# HISTORIC AND DESIGN REVIEW COMMISSION

**HDRC CASE NO:** 2020-462  
**ADDRESS:** 815 QUITMAN ST  
819 QUITMAN ST  
**LEGAL DESCRIPTION:** NCB 1255 BLK 3 LOT S 11.5 FT OF 39 & W 49.5 OF 42 ARB 42C  
NCB 1255 (SULLIVAN STUDIO SUBD), BLOCK 3 LOT 43  
**ZONING:** C-2, H  
**CITY COUNCIL DIST.:** 2  
**DISTRICT:** Government Hill Historic District  
**APPLICANT:** Mark Sullivan  
**OWNER:** Monique Garza/GARZA MONIQUE  
**TYPE OF WORK:** Amendment to a previously approved design regarding facade materials  
**APPLICATION RECEIVED:** August 30, 2022  
**60-DAY REVIEW:** Not applicable due to City Council Emergency Orders  
**CASE MANAGER:** Edward Hall

The applicant is requesting a Certificate of Appropriateness for approval to amend a previously approved design regarding facade materials.

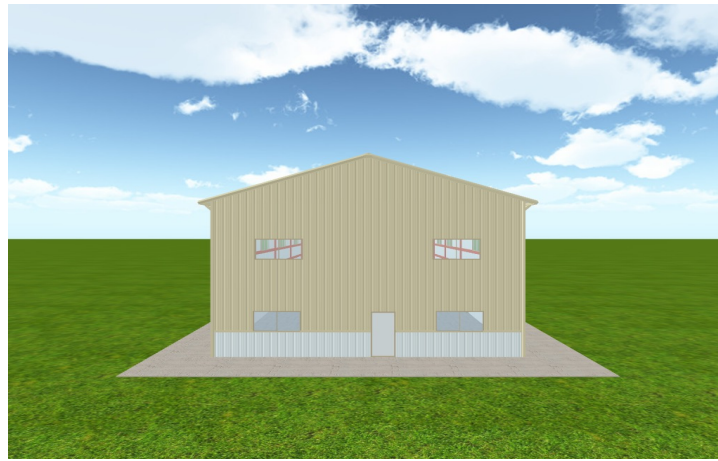
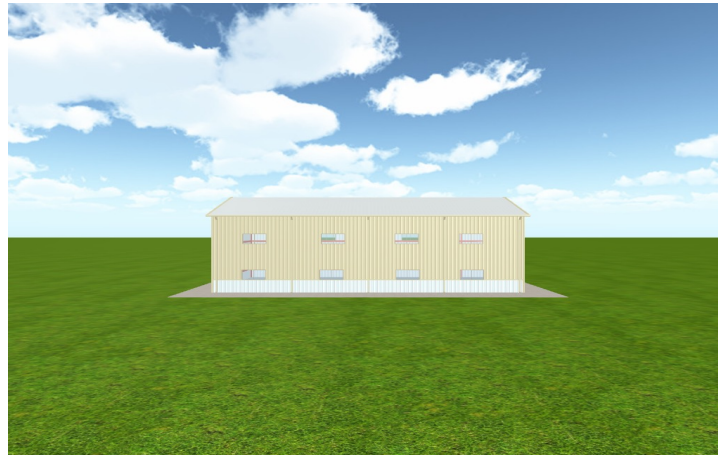
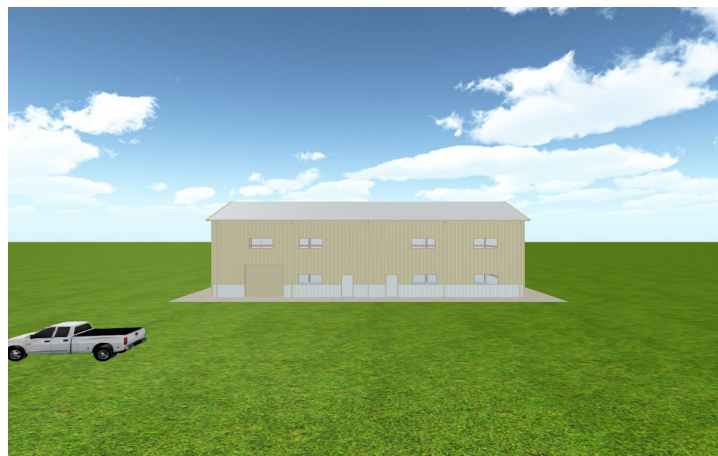
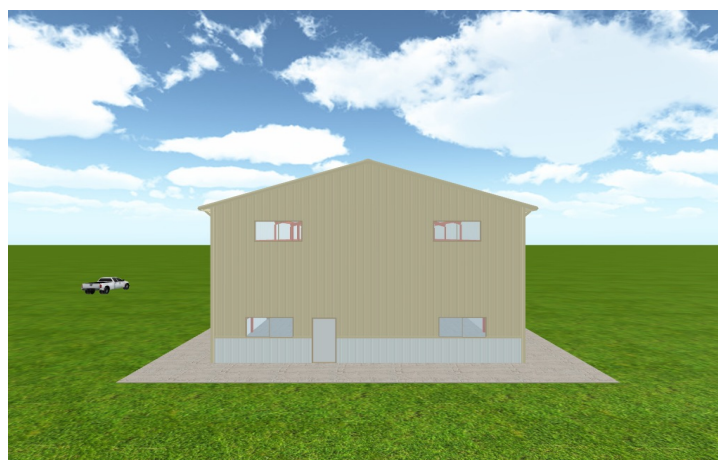
- c. DESIGN AMENDMENT – At this time, the applicant has proposed to amend the previously approved design regarding façade materials and the amount of exterior brick. The previously approved design featured full brick facades. At this time, the applicant has proposed to install only a brick wainscoting with the remaining façade featuring metal siding. Per the Guidelines for New Construction 3.A.i., applicants should use materials that complement the type, color, and texture of materials traditionally found in the district. Materials should not be so dissimilar as to distract from the historic interpretation of the district. Generally, staff finds the proposed amendment to be appropriate.

- d. DESIGN AMENDMENT – At this time the applicant has only proposed an amendment to the proposed amount of brick cladding installed on each façade. There have been no changes to the footprint or massing of the proposed structure. All stipulations of the original approval, noted in finding b, continue to apply.

- i. That the applicant submits final brick specifications to staff for review and approval.
- ii. That the applicant adhere to the stipulations of the original approval, as noted below:
  - a. If the deep front setback is used as proposed, then the site plan should feature a reduced parking pad paved area by half, where the plan currently depicts a nearly full width paved area with 4 parking spots set to the west property line.
  - b. The final window product should adhere to the Standard Specifications for Windows in New Construction.

## PREVIOUSLY APPROVED SITE PLAN

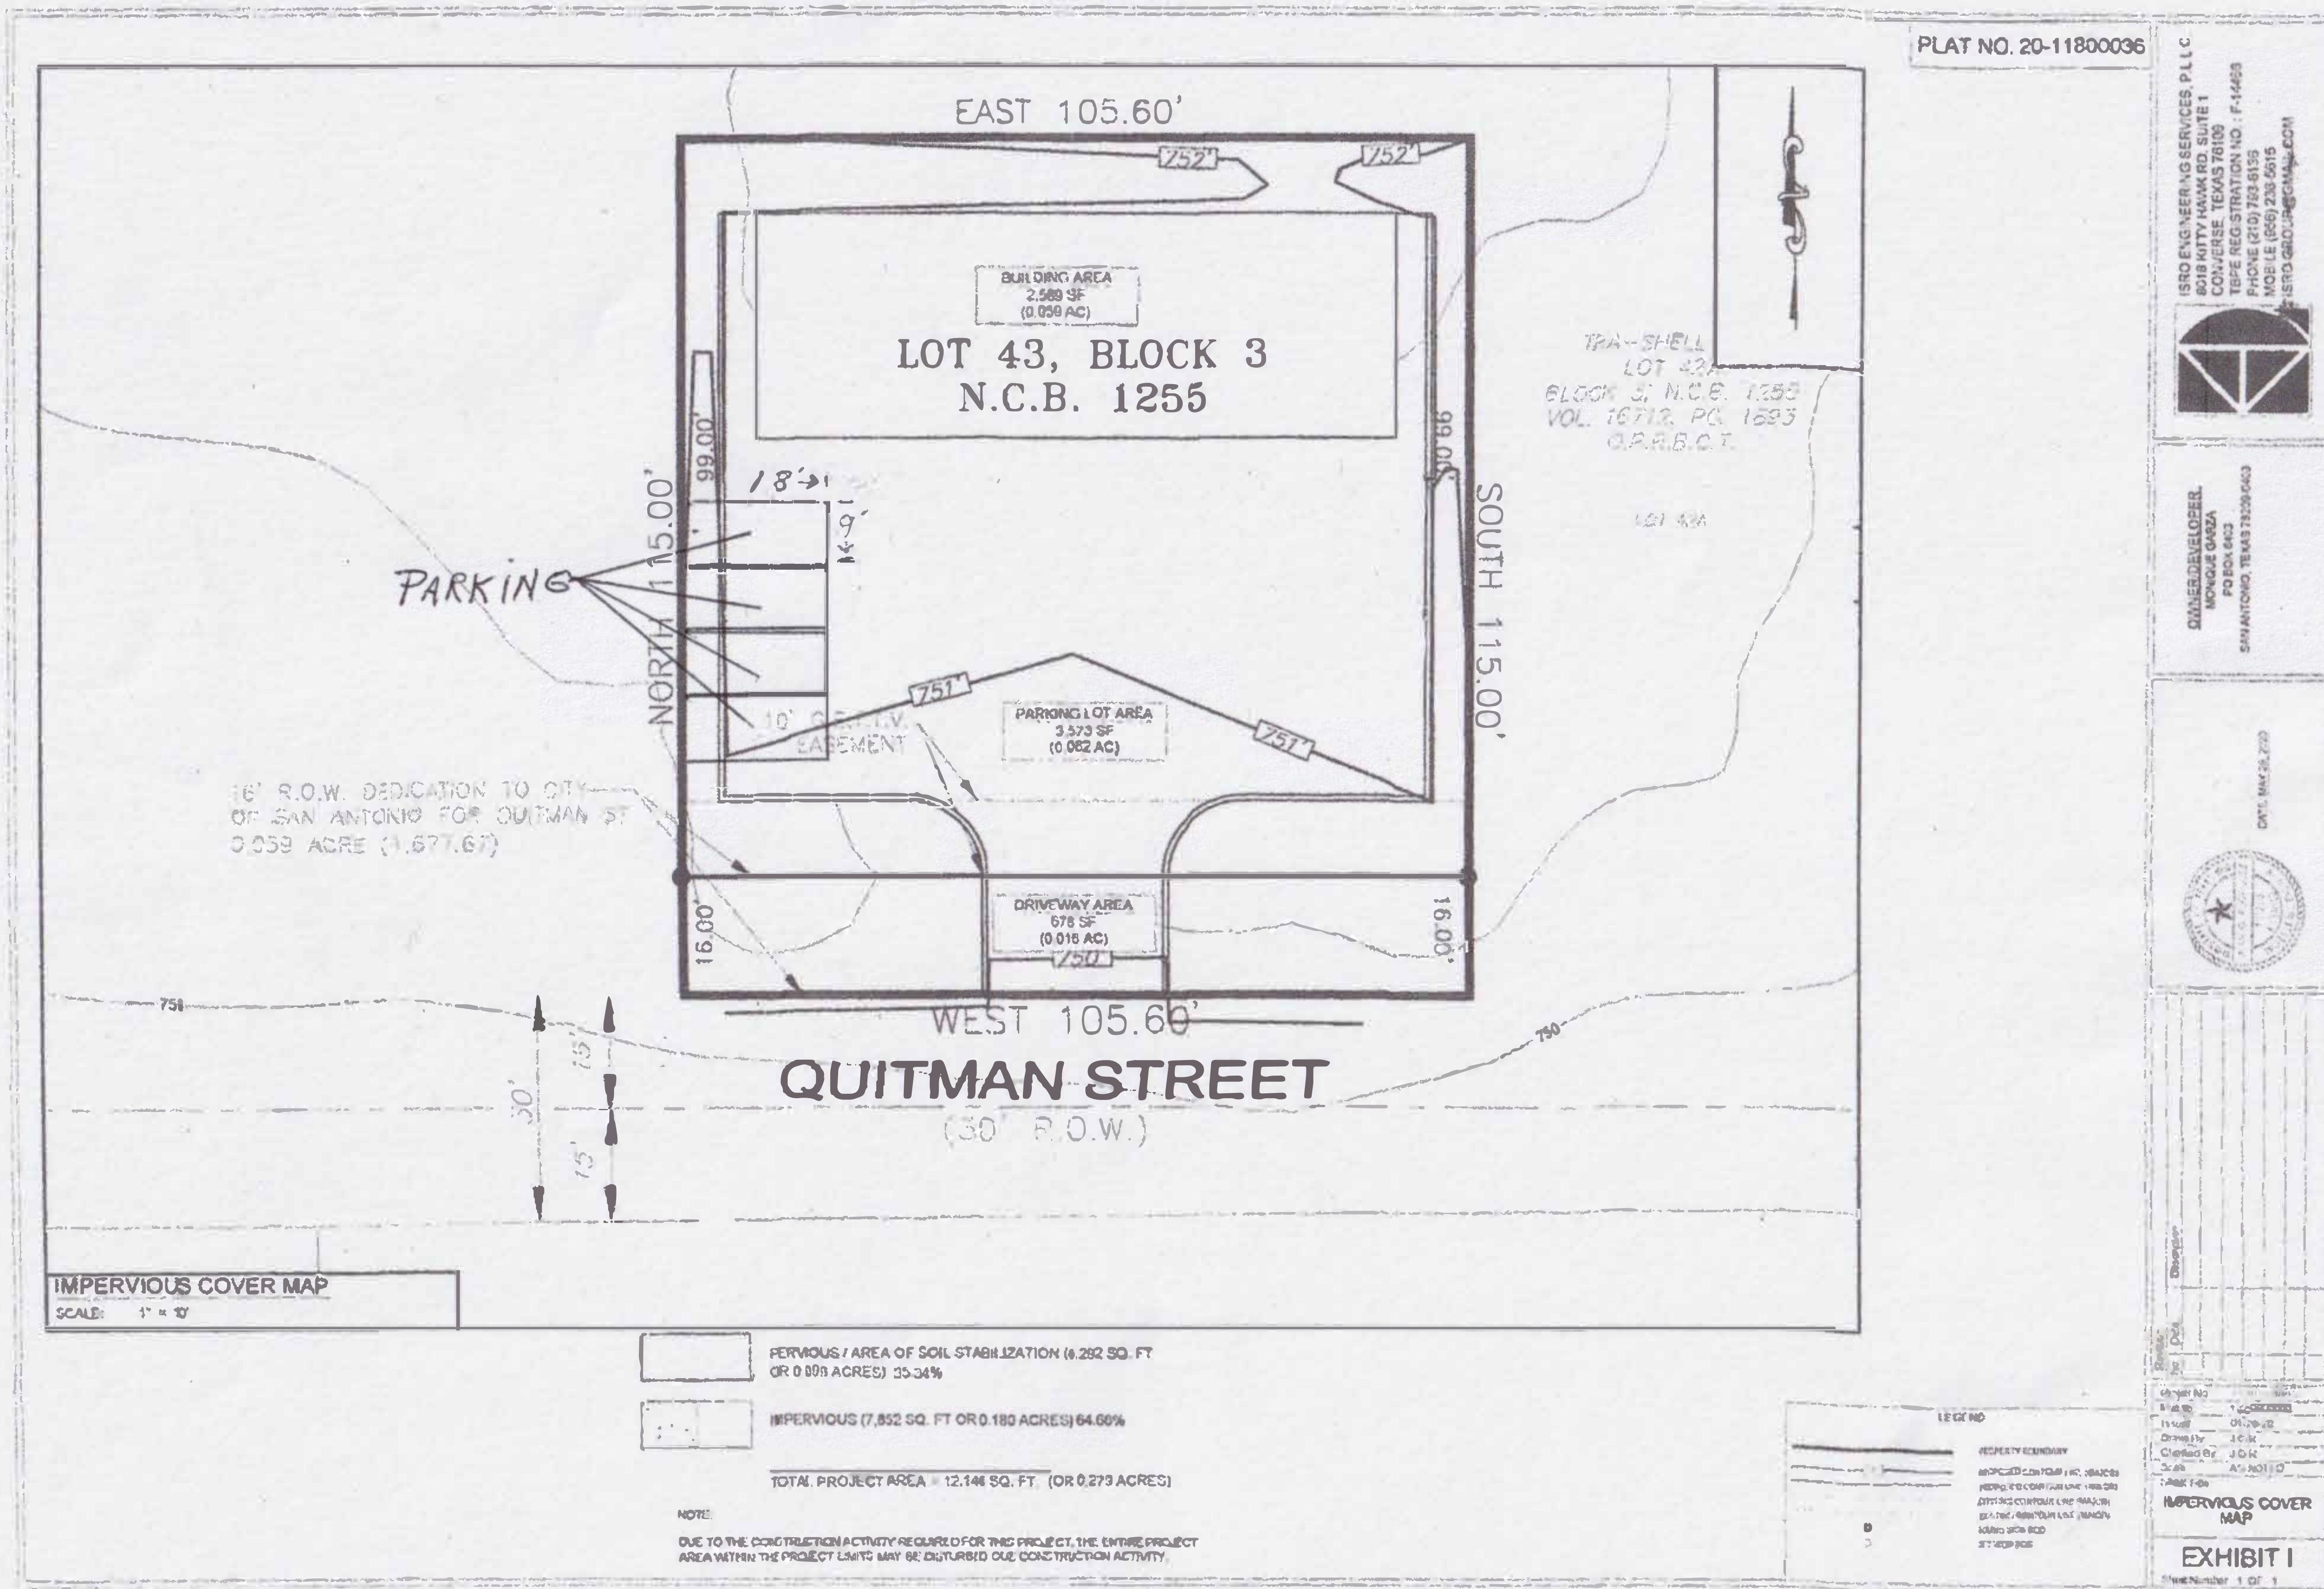
- i. If the deep front setback is used as proposed, then the site plan should feature a reduced parking pad paved area by half, where the plan currently depicts a nearly full width paved area with 4 parking spots set to the west property line.
